Office Action Summary	Application No. 10/566,869	Applicant(s) NAGAI ET AL.	
	Examiner THOMAS DIAZ	Art Unit 4171

DETAILED ACTION***Drawings***

FIG. 1

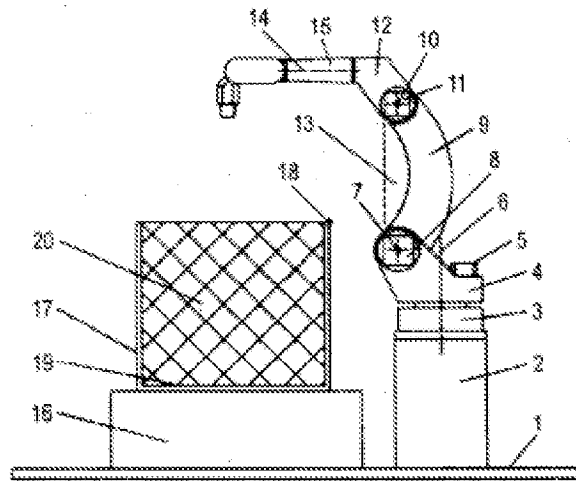
9. Applicant claims an industrial robotic arm as which is represented by Figure 1 below.

FIG. 1

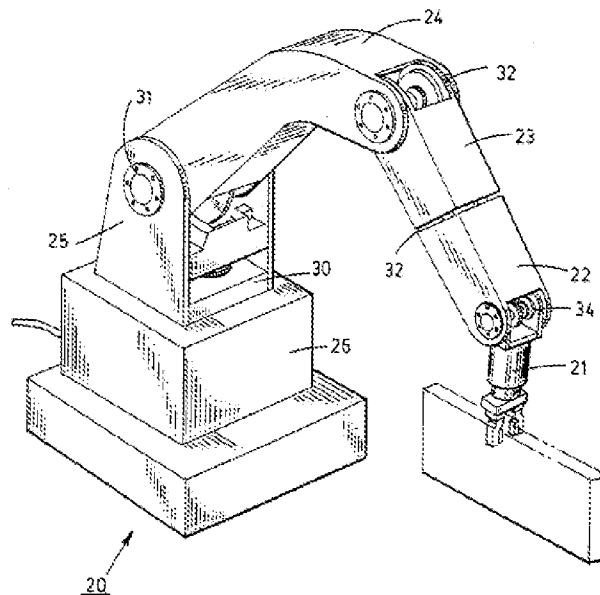
10. Huetsch teaches a robotic arm as shown below.

11. Regarding claim 1, the table below shows the relationship between applicant's claimed invention and Huetsch.

Claimed Limitations	Applicant's Ref. #	Huetsch's Ref. #
a base	3	26
a swing part	4	25
a first ("curved") arm	9	24
a second arm	12	23

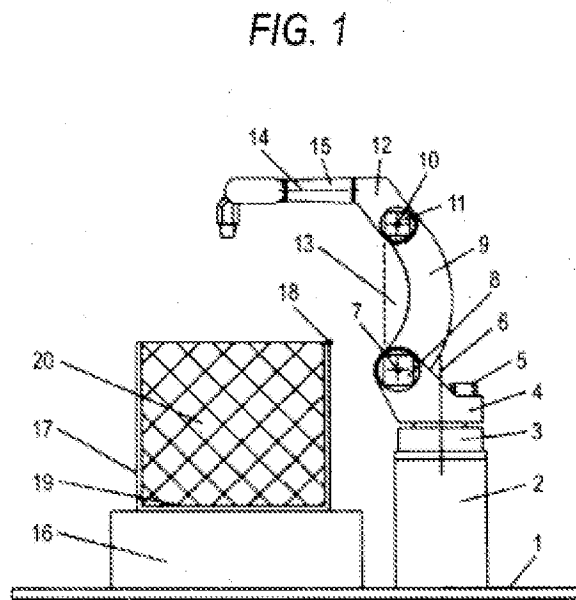
13. Regarding claims 3 and 4, applicant discloses that the center of gravity of the first arm is offset from the line connecting the rotating axes 8 and 10 due to said first arm

having curvature as depicted in applicant's figure. Since the shape of the prior art structure is substantially the same as the applicant's embodiment shown by Figure 1, the center of gravity will be inherently offset as claimed.

Fig.2

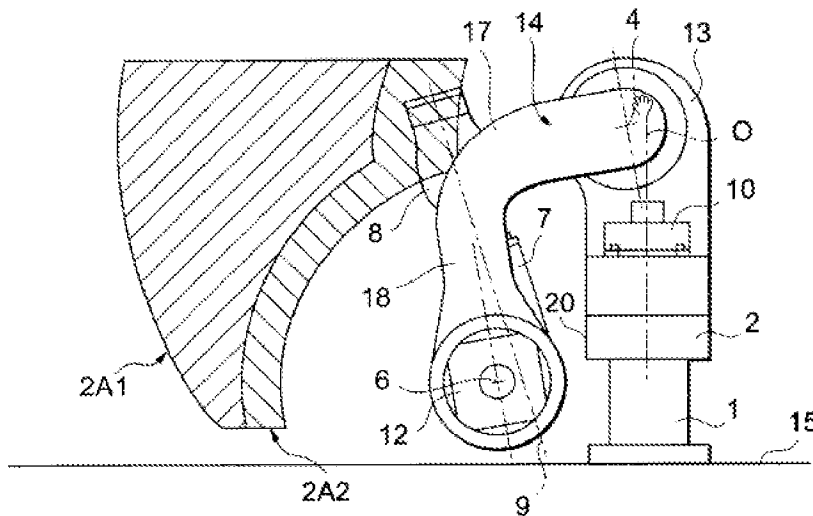
16. Murata et al. teach a robotic arm as shown below in Figure 2.

17. Regarding claims 1, the table below shows the relationship between applicant's claimed invention and Murata et al. .

Claimed Limitations	Applicant's Ref #	Huetsch's Ref #
a base	3	2
a swing part	4	13
a first ("curved") arm	9	14
a second arm	12	7

19. Regarding claims 3 and 4, applicant discloses that the center of gravity of said first arm is offset from the line connecting the rotating axes 8 and 10 due to said first arm having curvature depicted in applicant's figure. Murata et al. teach a first curved arm. Since the shape of the prior art structure is substantially the same as the
